Process Sheet

Customer	: CU-DAR001 Dart Helicopters Services	Drawing Name	: HEATER TUBE 3"		
Job Number	: 35340	Part Number	: D2407		
Estimate Number	: 10471	Drawing Number	: D2407 REV. A		
P.O. Number	: N/A	Project Number	: N/A		
This Issue	: 24/10/2007 S.O. No. : N/A	Drawing Revision	: A		
Prsht Rev.	: NC	Material	: N/A		
First Issue	: N/A	Type	: SMALL /MED FAB		
Previous Run	: 26915	Due Date	: 31/10/2007	Qty:	6 Um: Each
Written By					
Checked & Approved By					
Comment	: Est: C 03.04.14 Reformat; Incorporated D2292; D2375-3-08-106; D2403 - D2417 KJ/RF

PREPARED		DART AERO ACCESSORIES INC	
B. Williams		VICTORIA INTERNATIONAL AIRPORT, CANADA	
CHECKED	APPROVED	REV. A	
BW	BW	D2407	
DATE		SHEET 1 OF 1	
Apr. 6, 1995		TITLE	
		3" HEATER TUBE	
		SCALE	
		1:1

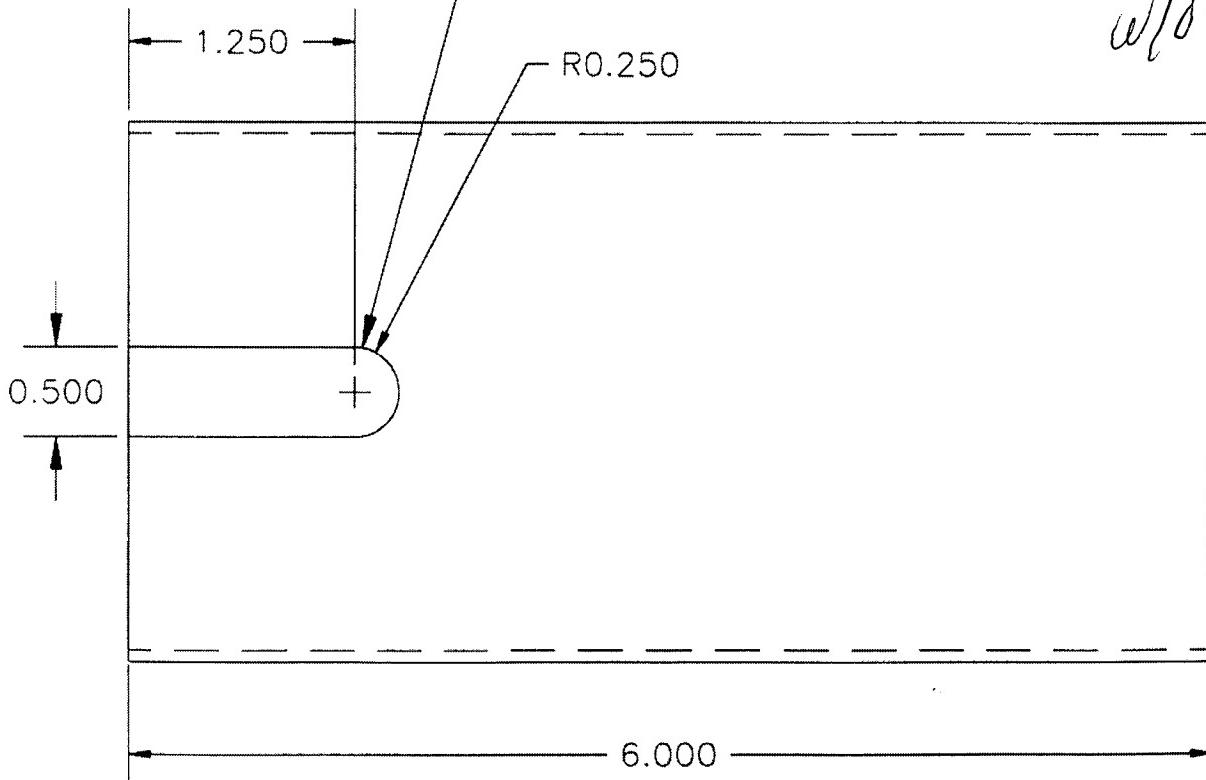
NCR:		WORK ORDER NON-CONFORMANCE (NCR)						
DATE	STEP	Description of NC Section A	Corrective Action Section B			Verification Section C	Approval Chief Eng	Approval QC Inspector
			Initial Chief Eng	Action Description Chief Eng	Sign & Date			
07/10/26	# 2.1.	two parts size are ^{0.040"} under normal. They were cut using a chop saw.	LE 07.10.26 QS1042	Parts Are Acceptable. This one time only.	LE 07.10.26	EP 07/10/26	LE 07.10.26 QS1042	EP 07/10/26
				Change w/o to use Jasper saw and to be cut by Hand.	AS 07/10/29

W/O:		WORK ORDER CHANGES					
DATE	STEP	PROCEDURE CHANGE	By	Date	Qty	Approval Chief Eng / Prod Mgr	Approval QC Inspector
07/10/26	# 2.0	Perment change. use Jasper saw to cut parts to length.	AS	07/10/29	1	ES 07/10/29	ES 07/10/26
